STATE OF NEW YORK DEPARTMENT OF PUBLIC SERVICE

Re: Case 80008 - Information Requests Relating to
Aesthetics at the New Haven Area;

CASE 80008 - Information Request Relating to Aesthetics at the New Haven Site, 16 NYCRR PART 77.

CASE 80008 - Information Requests Relating to Geology and Seismology in the New Haven Area, 16 NYCRR Part 76.

FIGURE 3-3 NW 1/4 SECTION 36

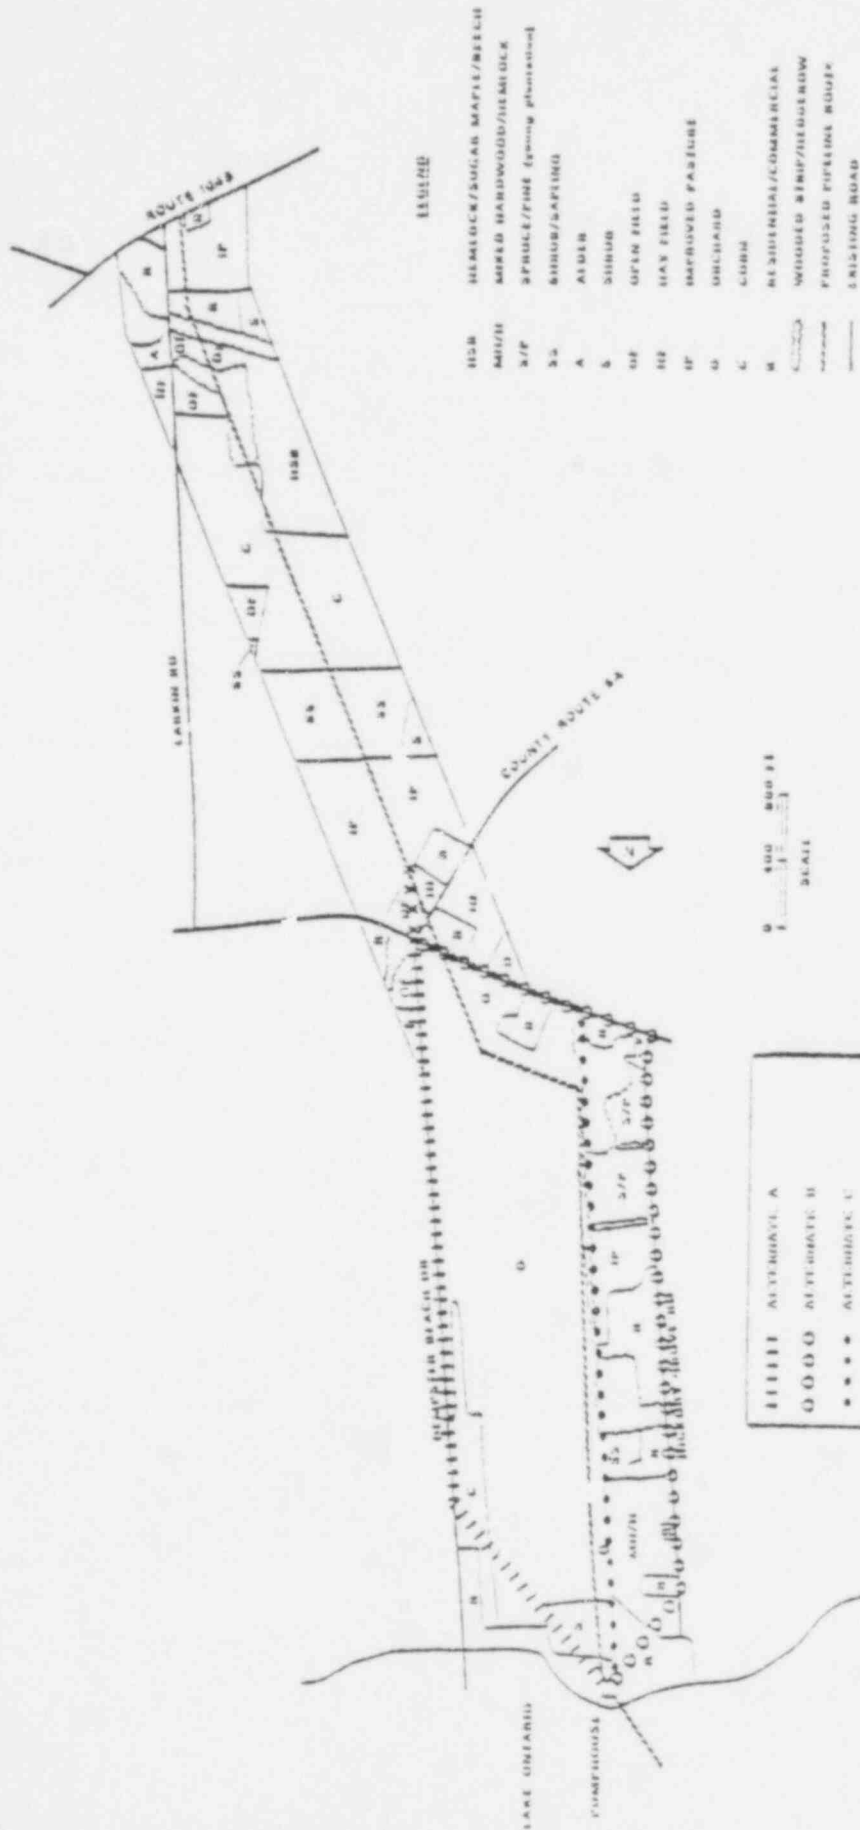
77-26 Section 4.1 and Figure 4.1-4 of the application indicate that the off-site pipeline route will go through an orchard between Dempster Beach Drive and Hickory Grove Road. Please discuss:

- a. The extent of clearing of 6-9 acres of the orchard, i.e., approximate number, age and average yield of the fruit trees.
- b. The time periods when this area will be disturbed and the effect of construction on the activities on the entire orchard, i.e., the ability of the farmer to move through the orchard in a normal course of his activities of pruning, spraying, harvesting, etc.

- c. The extent of disruption of sub-surface drain fields in access roads, if any, and the plans to restore these systems.
- d. The engineering, economic, land use and environmental costs and benefits of relocating this section of pipeline in a manner which will reduce the disruption of the orchard, e.g., along the Dempster Beach Drive right-of-way, or further to the west of the edge of the orchard.

- f. Has the applicant considered the two alternate routes as indicated in the attached reference Figure 4.1-4? What are the advantages and/or disadvantages to each of these alternate routes?
